UNITED STATES PATENT AND TRADEMARK OFFICE

10/552,387

Office Action Summary	Application No. 10/552,387	Applicant(s) INOSE ET AL.	
	Examiner DORON D. FIELDS	Art Unit 4143

DETAILED ACTION

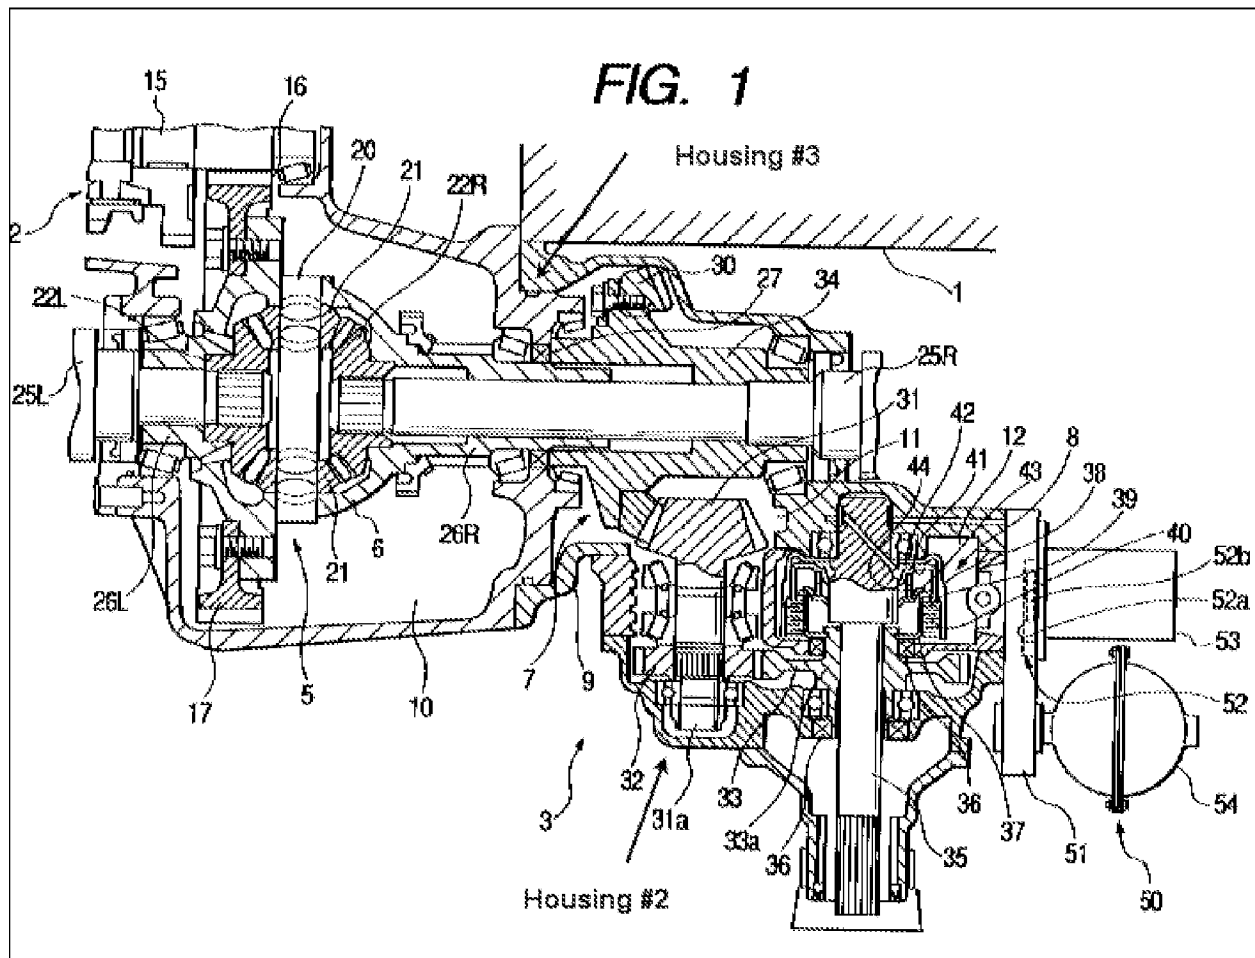
- *the housing member comprises a first housing member, a second housing member and a third housing member (see at least Fig 1),*
- *one of the pair of the first bearings, one of the pair of the second bearings and one of the pair of the third bearings are housed in the first housing member (see at least Fig 1; entire housing),*
- *another of the pair of the first bearings and another of the pair of the second bearings are housed in the second housing member (see at least modified Fig 1 below) , and*
- *another of the pair of the third bearings is housed in the third housing member (see at least modified Fig 1 below).*
